SIM 61 01 23

2023-03-23

SERVICE ACTION: (12V) BATTERY BOX COVER REPLACEMENT

SITUATION

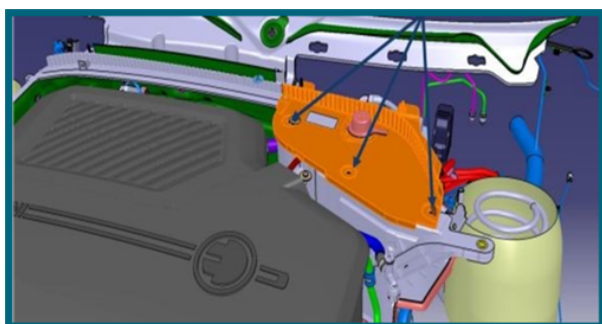
Oscillations in the electric drive can occur. As a result, the 12 V positive battery cable may rub against the battery box cover.

Replace the 12 V battery box cover.

Tolerance sample catalogue

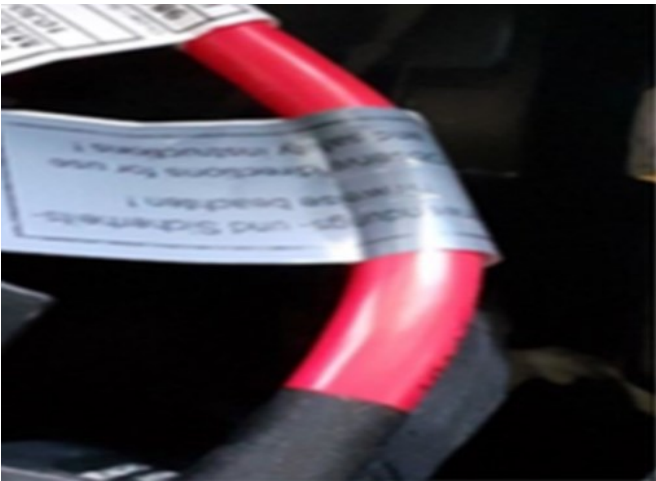
1. No Damage

2. Slight Dent without abrasion.

3. Abrasion can be detected on a large area.

4. Abrasion on large area deep notch.

5. Extreme dent on a large area.

| Degree of damage | Replacement of battery box cover | Replace the positive battery cable |
|------------------|----------------------------------|------------------------------------|
| Example 1/2/3/4 | Replace | --- |
| Example 5 | Replace | Replace |
